UNITED STATES
NUCLEAR REGULATORY COMMISSION

LICENSEES: Tennessee Valley Authority

FACILITIES: Watts Bar Nuclear Plant, Unit 1

SUBJECT: SUMMARY OF FEBRUARY 9, 2000 MEETING ON REACTOR VESSEL
SURVEILLANCE SPECIMEN TESTING (TAC No. M89606)

WBN CAPSULE U REMAINING CT SPECIMEN
CONFIGURATION

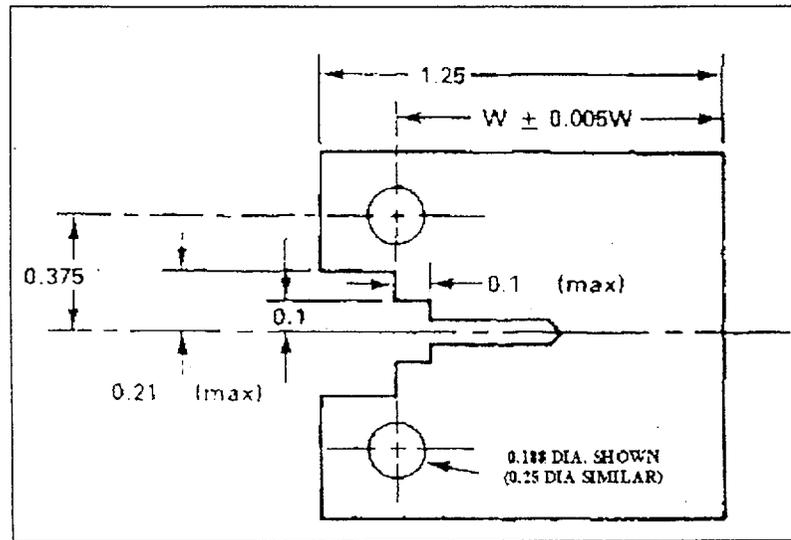
The licensee was concerned that the irradiated compact fracture toughness specimens geometry was not in compliance with the American Society for Testing and Materials (ASTM) standard for fracture toughness testing and would not provide acceptable test results (TVA slide 8). The staff recommended that to respond to this concern, TVA may wish to (1) propose to the ASTM standard development committee that the WBN irradiated specimens geometry

- Problems that have occurred.
 - Because TVA did not make a formal commitment to submit the J-R curve information the action was not tracked to completion.
 - WBN surveillance capsule CT coupons configured for testing in accordance with ASTM E399-1974.
 - TVA submitted analysis results from first specimen in accordance with 10 CFR 50 Appendix H.

- J-R test coupons can not physically be configured from CT coupons to perform J-R curve testing according to today's best practice.
